**INTERNATIONAL STANDARD ISO 9100-3:2005**  
**TECHNICAL CORRIGENDUM 1**

**Glass containers — Vacuum lug finishes —**

**Part 3:**  
**38 regular**

**TECHNICAL CORRIGENDUM 1**

Figure 1 — Thread construction and enlarged view section B-B

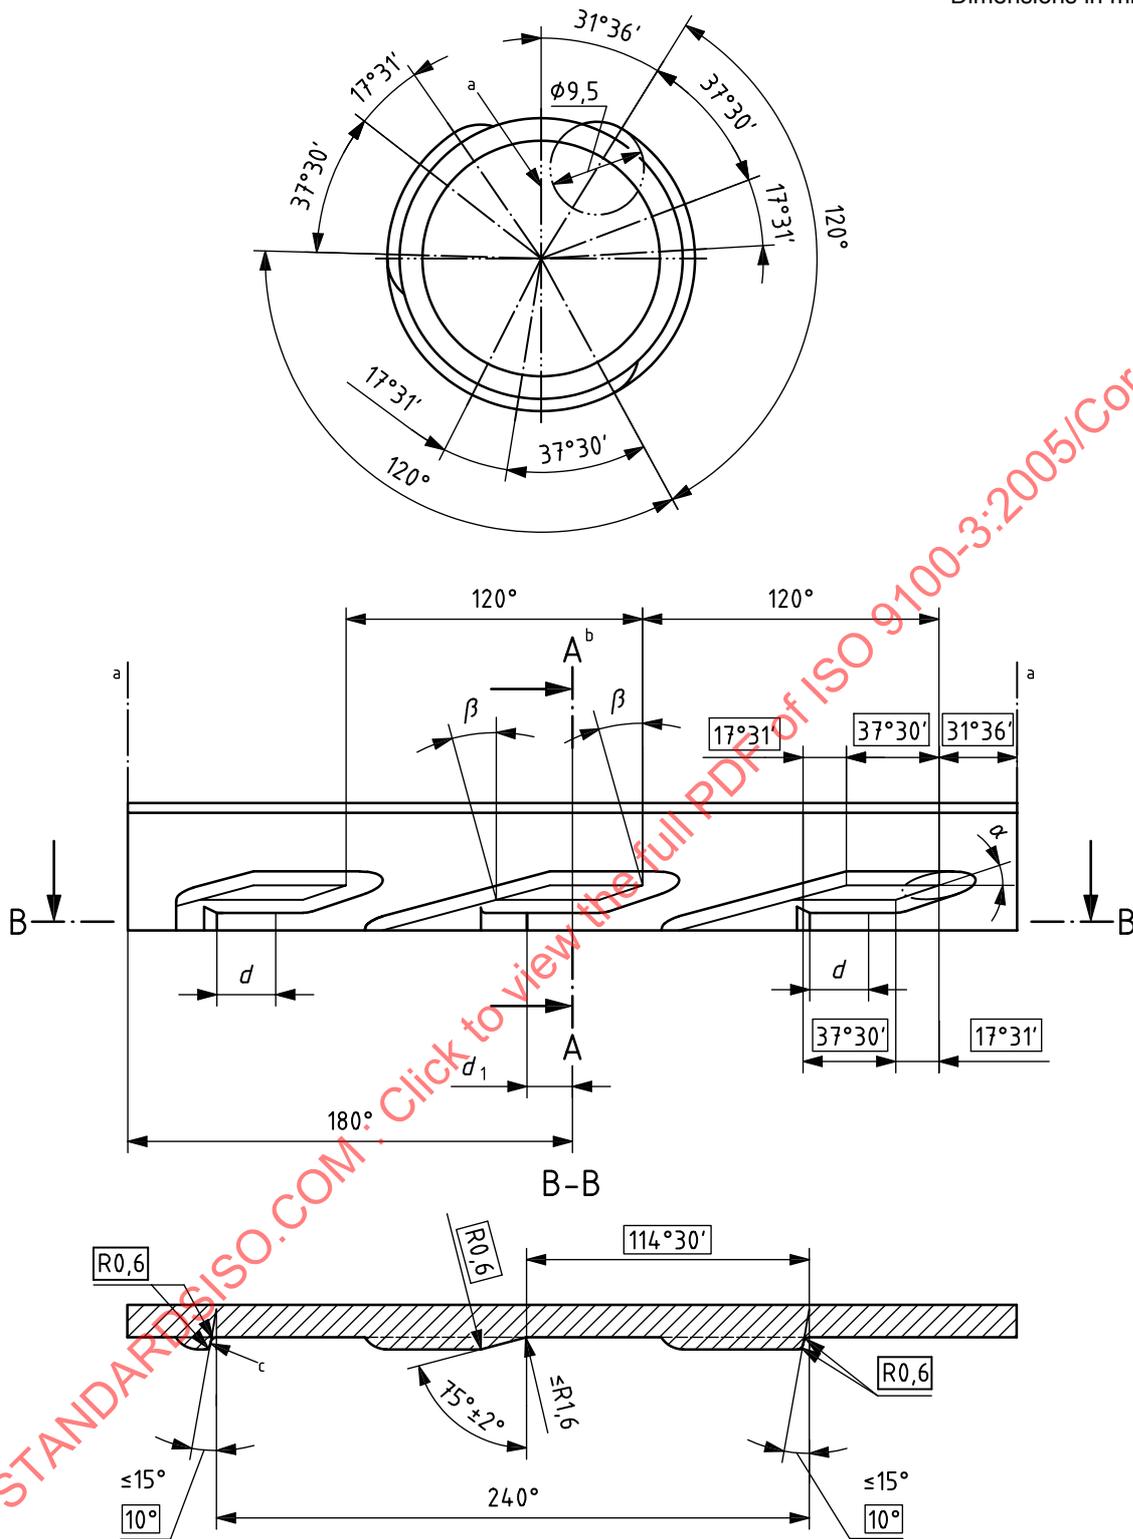
*Page 2, Figure 1*

Replace Figure 1 with the following figure. (In the enlarged view section B-B, the arrow for footnote “c” has been moved to the right of the stop face.)

c The stop faces on the leads have a cap stopping function. Thus they shall be sharp-edged and as perpendicular to the E-wall as possible. The radii of the stop faces should be the same as of the mould. A punctual replacement of moulds is necessary to prevent worn contours.
